Comments 254 Kansas
.com	Application No.: CPR-2019004211 Project Planner.: Ryan Loomis
	Notes
density is 30 du/acre with the 7 units. Per Basic Townsite lots over 10,000 SF are permitted Ind 24 du's per acre. (CD)	Lot Area: 9925 sf per Survey
includes a Design Review with Modification due or allowable density. This requires Planning ew. (CD)	Lot Area: 9925 sf per Survey
uture Design Review application provides items ecklist, including items requested below. (CD)	
provides legible dimensions, street names, alley, D)	
n items (doors, rooms, etc.) from the site plan.	
n the walls, utility boxes, etc. A six-foot high (6 ft.) decorative masonry, vinyl, wood, or opaque uired when abutting a single-family residential lot.	
of the building and all setbacks. Building is over	Bldg over parking deleted
information as far as # of units proposed, open	
row with actual and plan north. Ensure elevation ect direction. (CD)

Comments | 254 Kansas

DR-1.1

#Building ID Project No: SHEET Print Date 2/24/20 Project Info

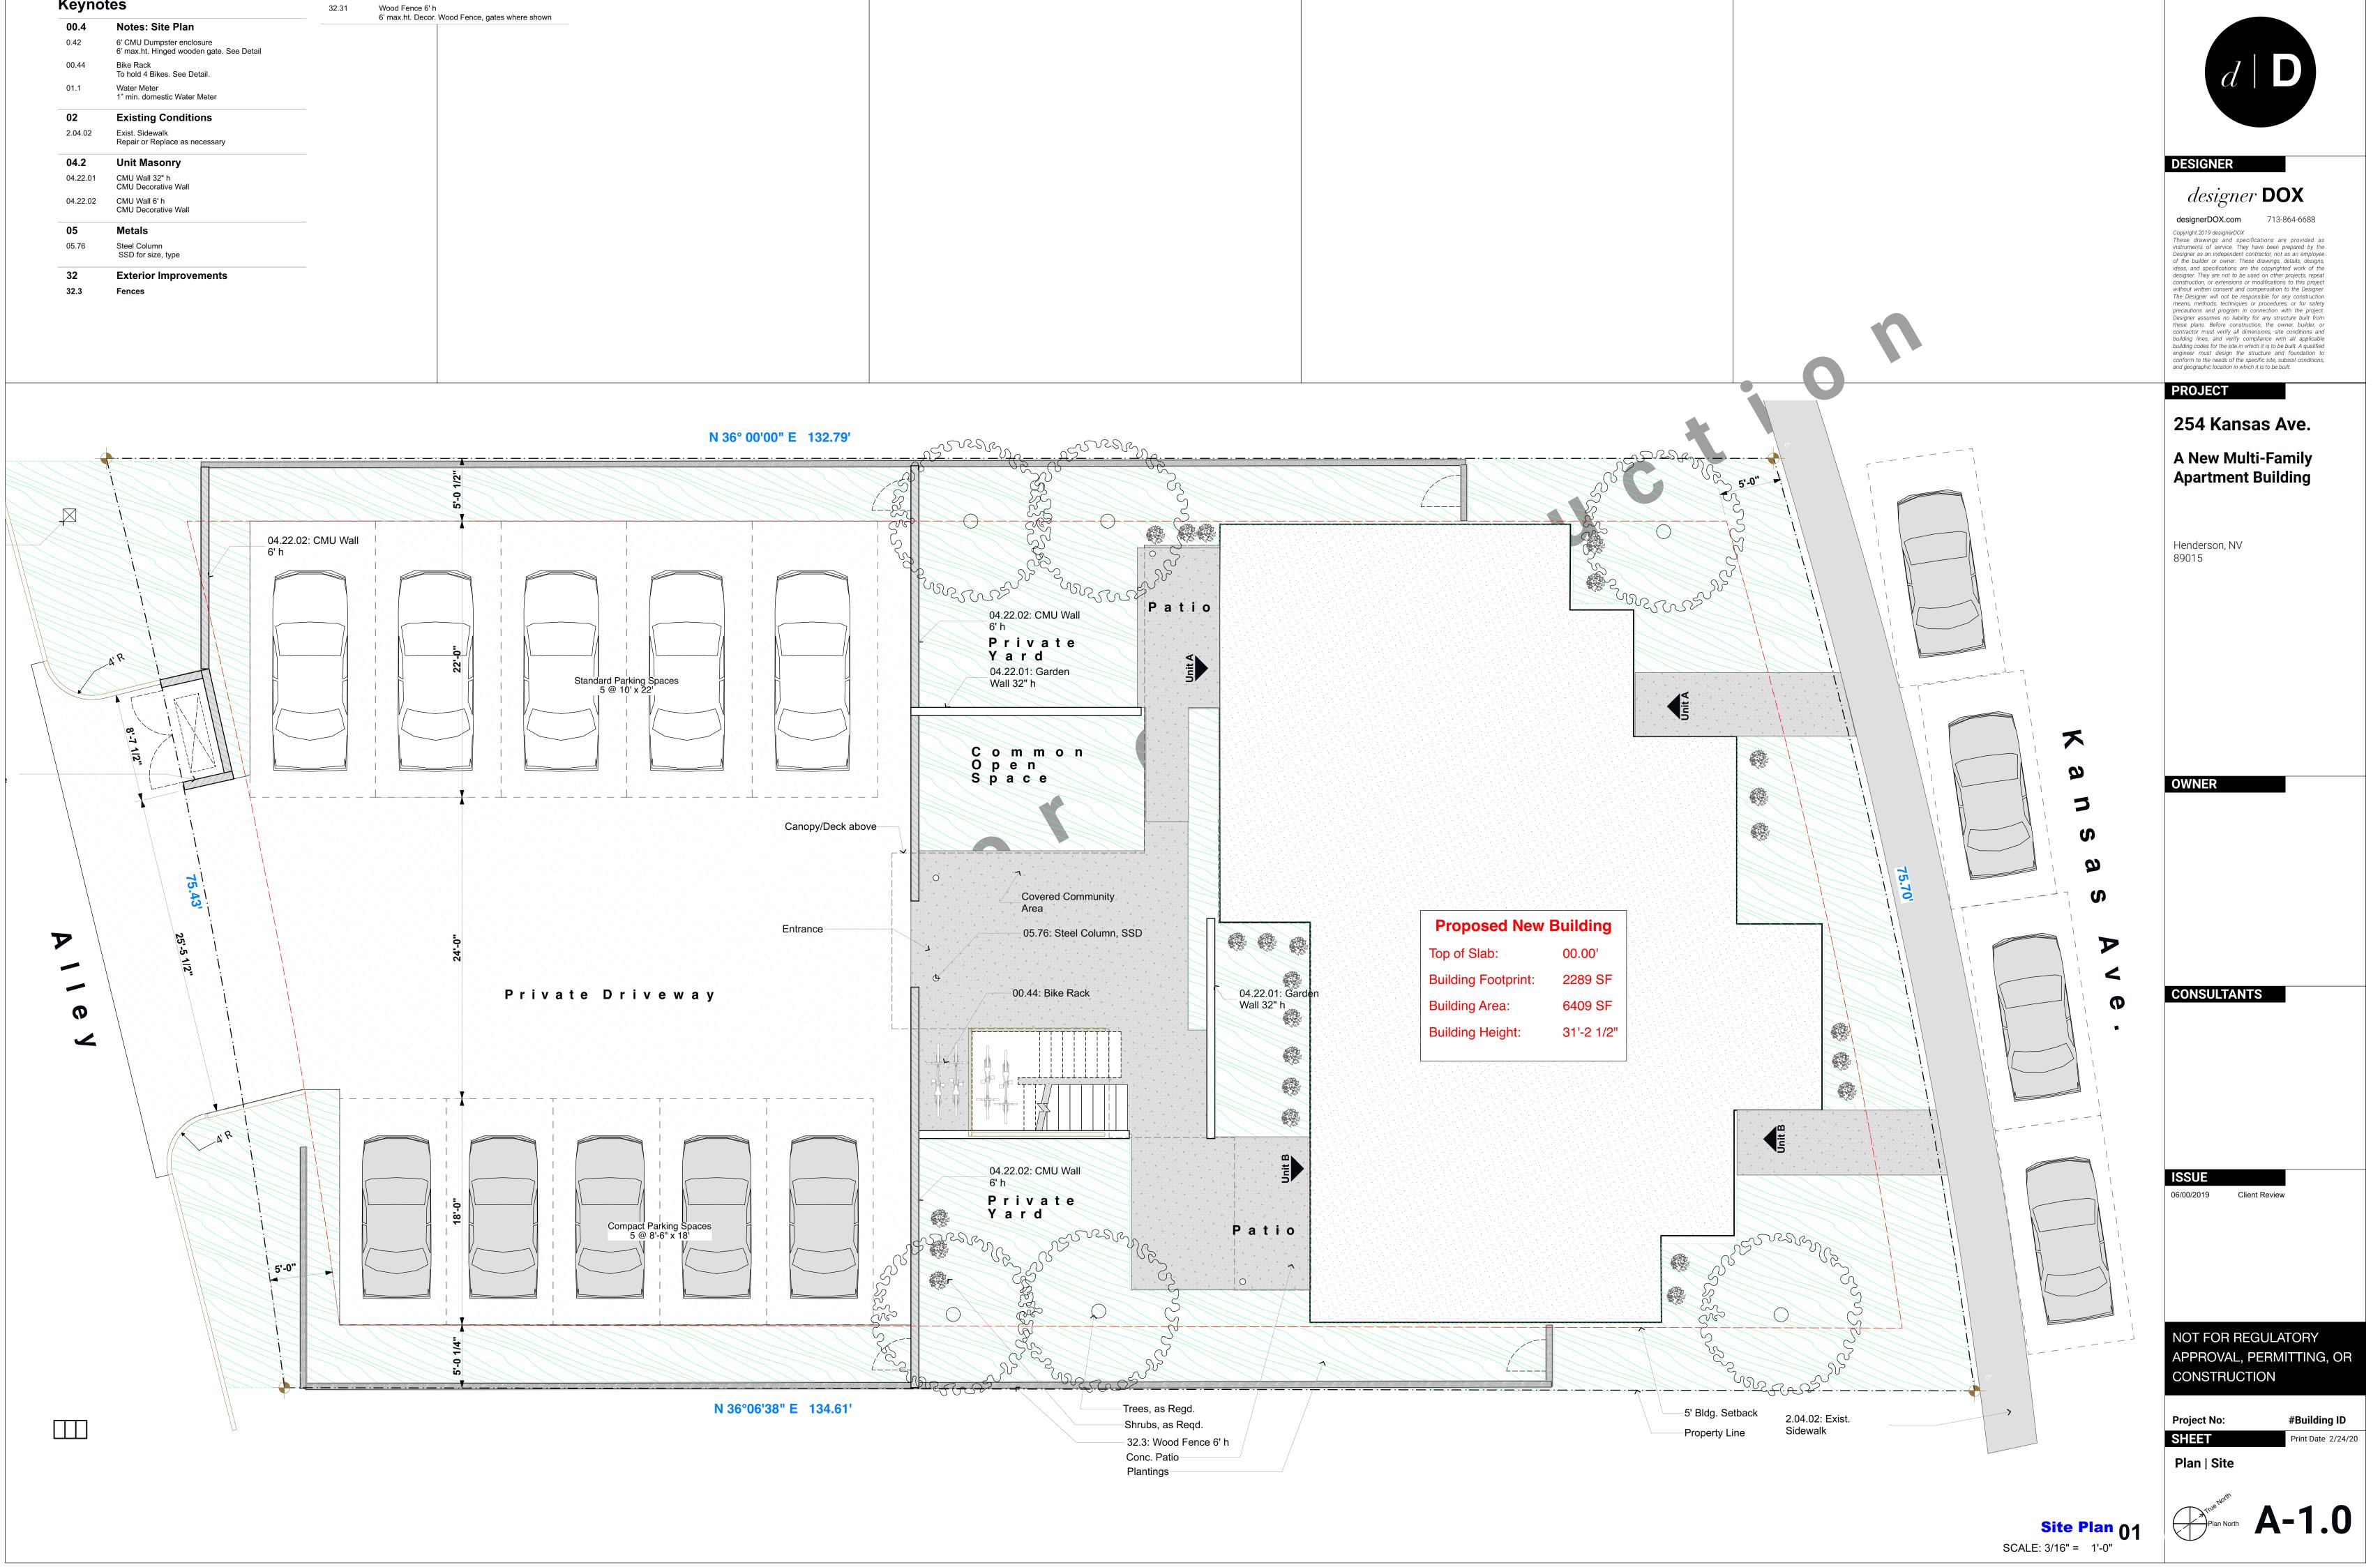
7.	A-1.0 Site Plan	Show the outline of the bu parking? (CD)
8.	A-0.0 Cover Sheet	Provide site data informati space, etc. (CD)
9.	In Title Block of all plan sheets	Provide north arrow with a sheets have correct direction

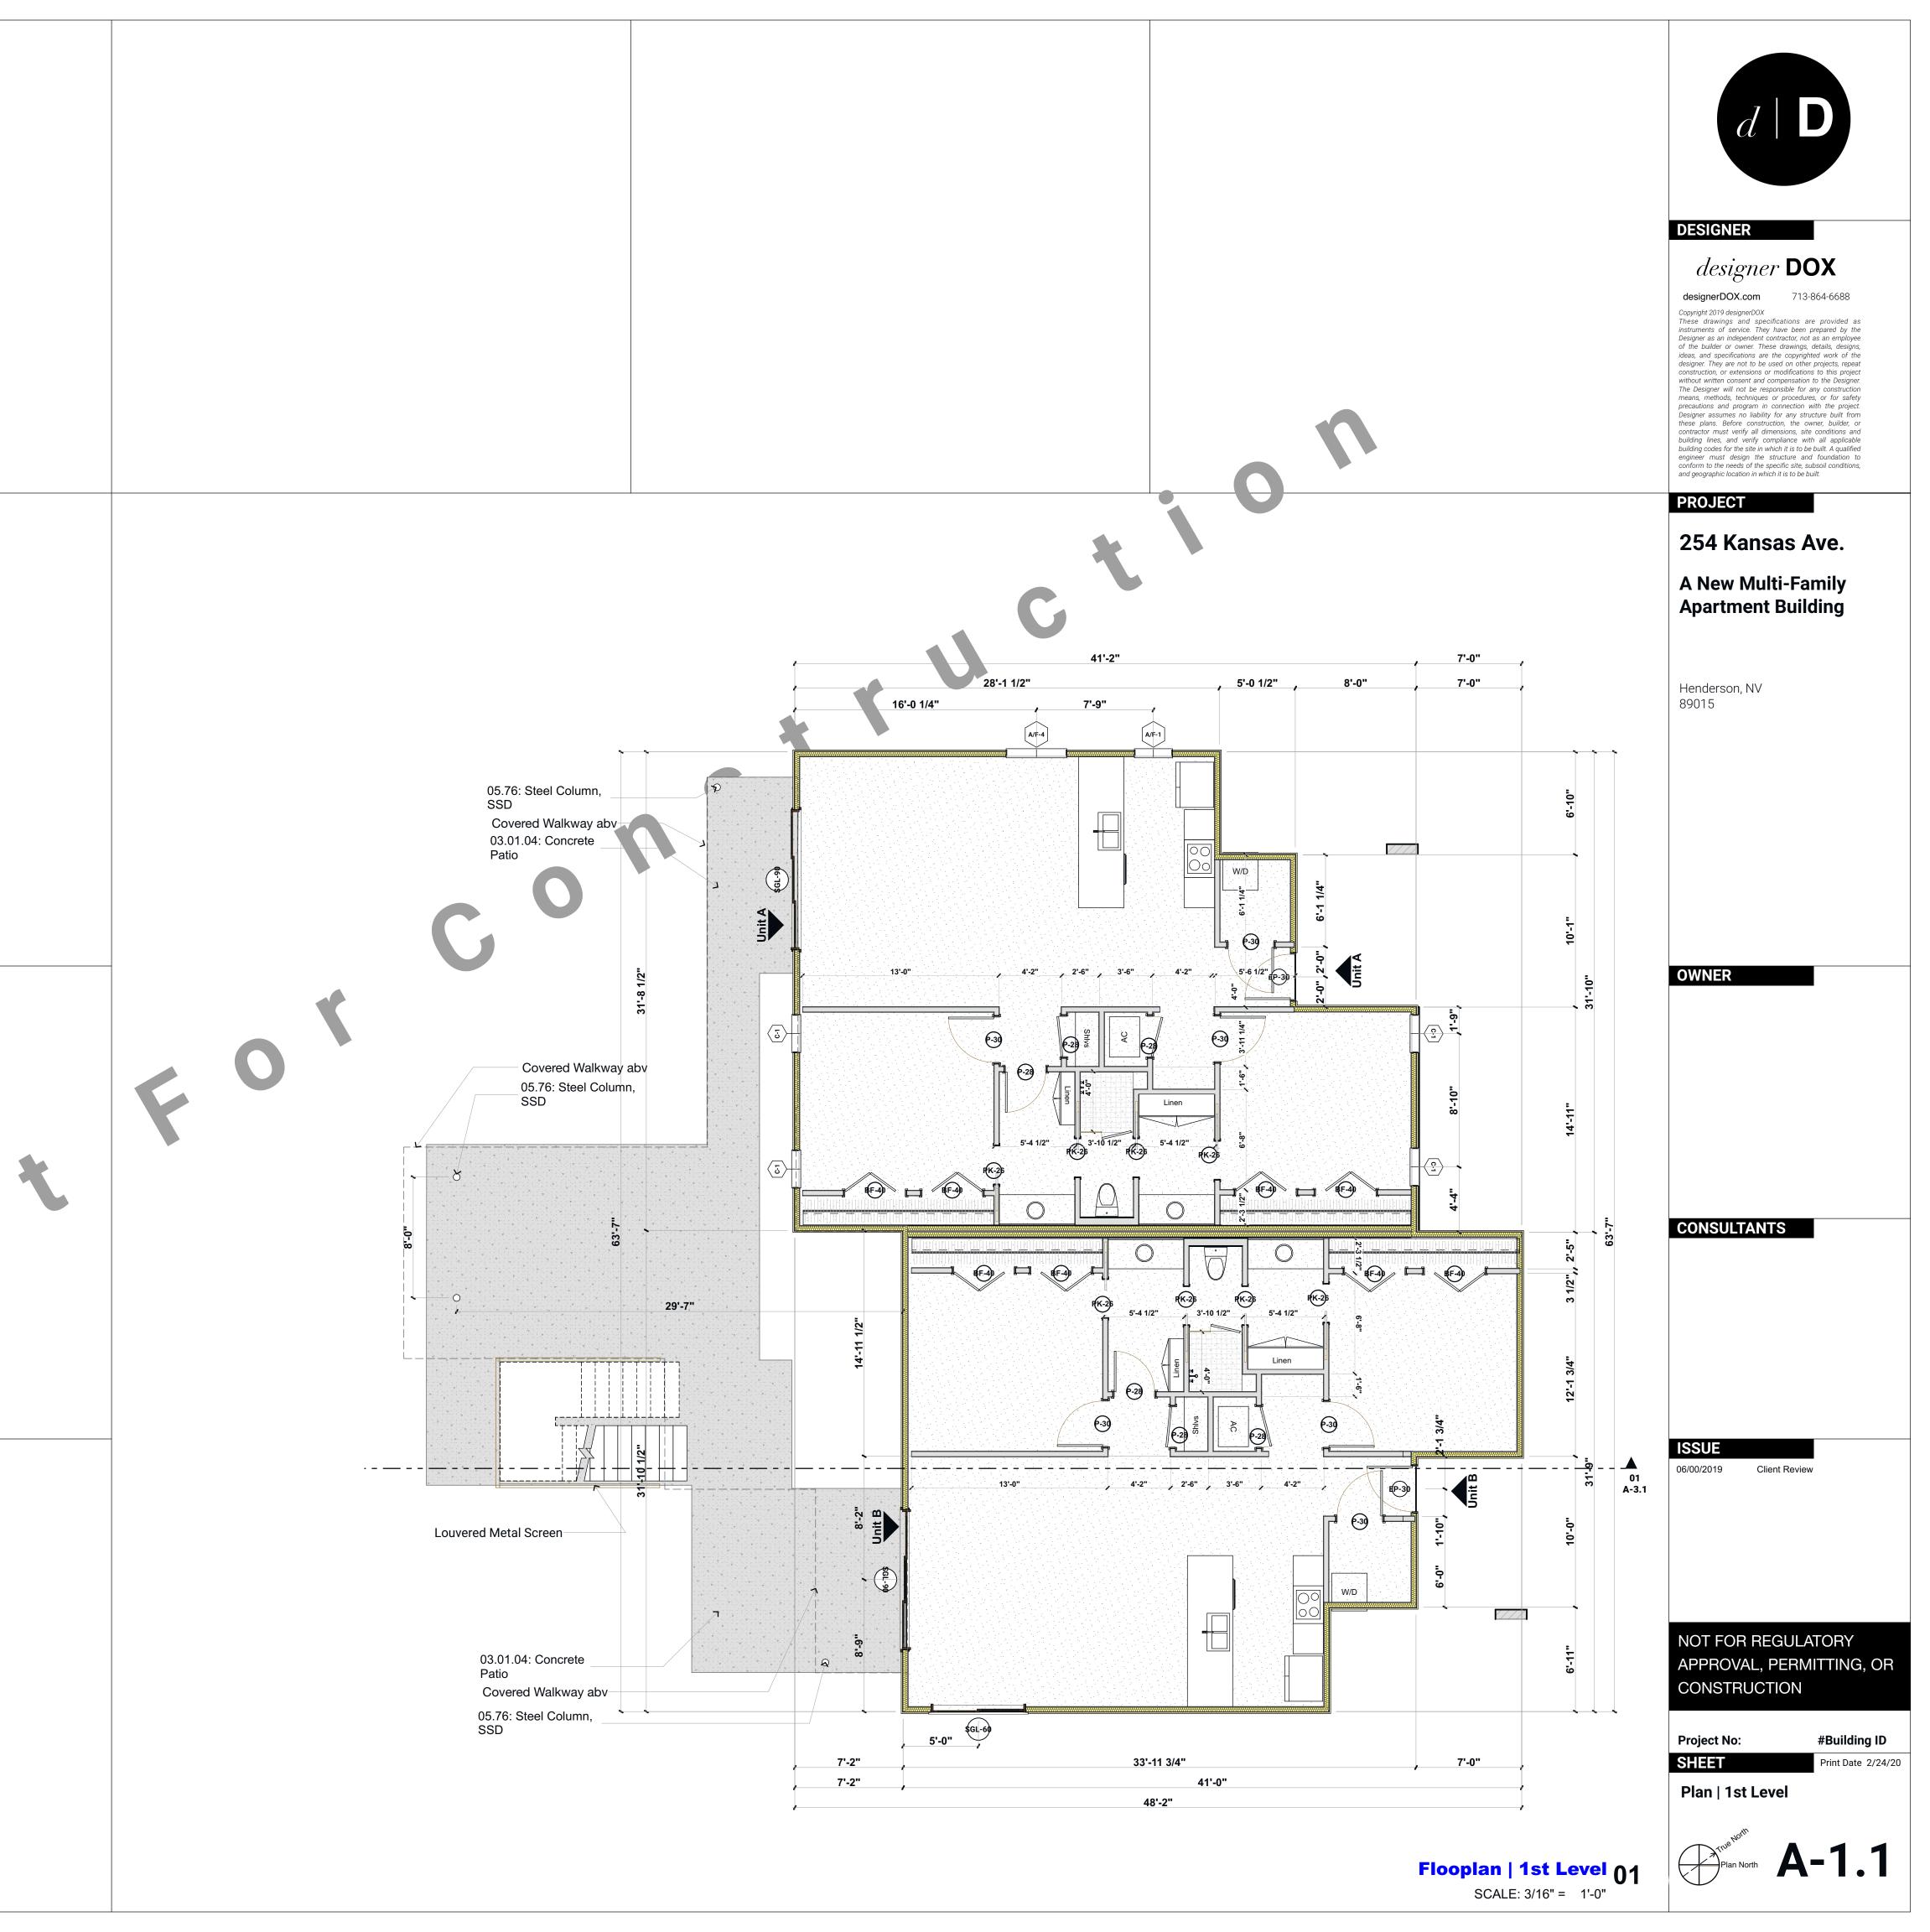
2.		Future submittal includes to density over allowal Commission review. (CD)
3.		Please ensure future Des requested on checklist, inc
4.	A-1.0 Site Plan	Ensure site plan provides setbacks, etc. (CD)

5.	A-1.0 Site Plan	Remove floorplan items ((CD)
6.	A-1.0 Site Plan	Label on site plan the walls privacy fence (decorativ vegetative) is required whe (CD)

10.	A-1.0 Site Plan	Provide parking space wid
11.	A-1.0 Site Plan	Show a bicycle parking s where no less than four bik
12.	A-1.0 Site Plan	Elevations seem to show

15.	A-1.3 Roof Plan	Please show location of HVAC. Provide screening p Screening. (CD)
16.	A-1.0 Site Plan	Please show amount of development is required t open space per residentia space not
